Product Change Notification

PCN-PCC-3505-2019

Business Unit	Product Line Code	Type of Change	Action	Date of Issue
PCC - PCB Connectors	AAA	Product Change Notification	Notify Distributors and Field	4/17/2019

Description for Product Change Notification

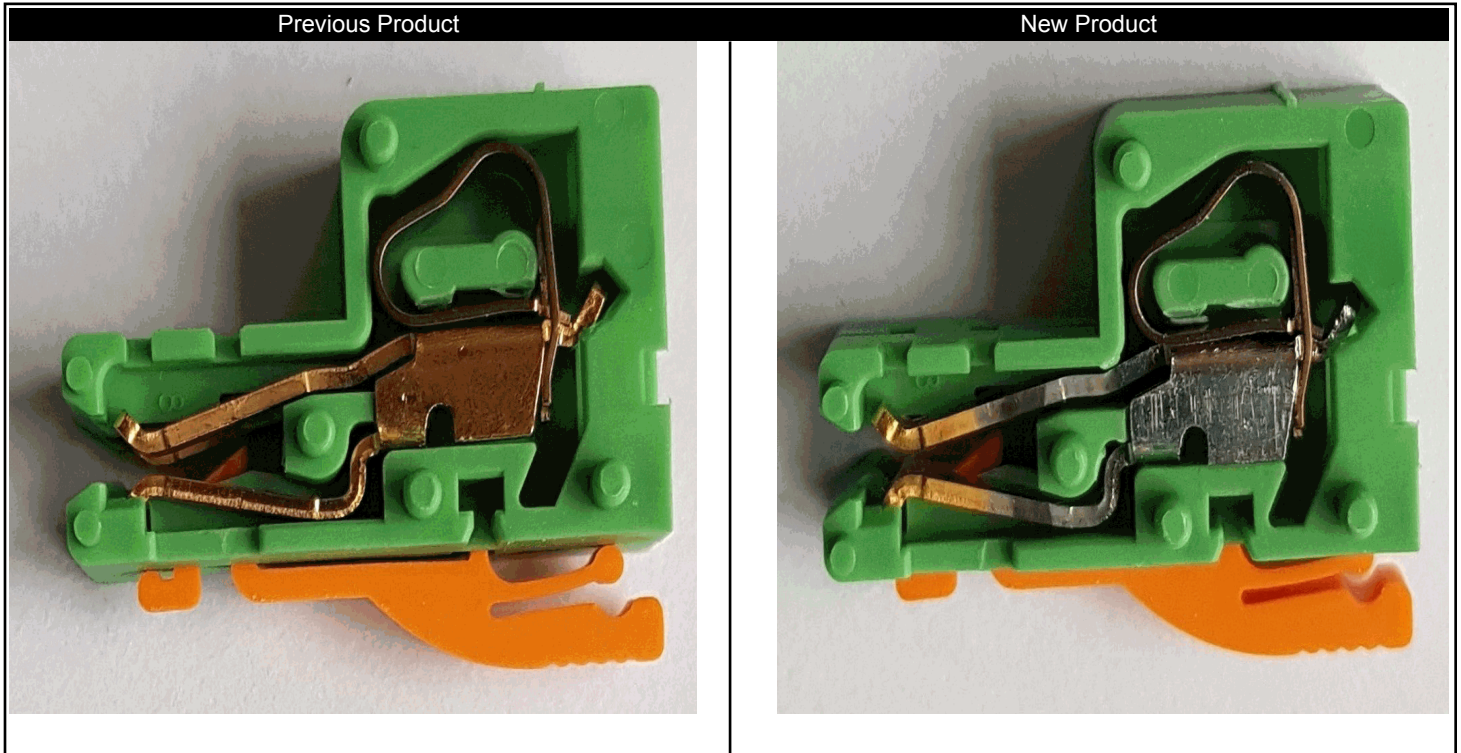
To optimize the production process we have change the metal contact from a complete to a partially gold-plated surface. This change does not increase the contact resistance. Also dimensions and technical data are not affected by this modification. Version/revision level will be adjusted per the attached spreadsheet. During the conversion phase both versions will be delivered, depending on the local inventory.
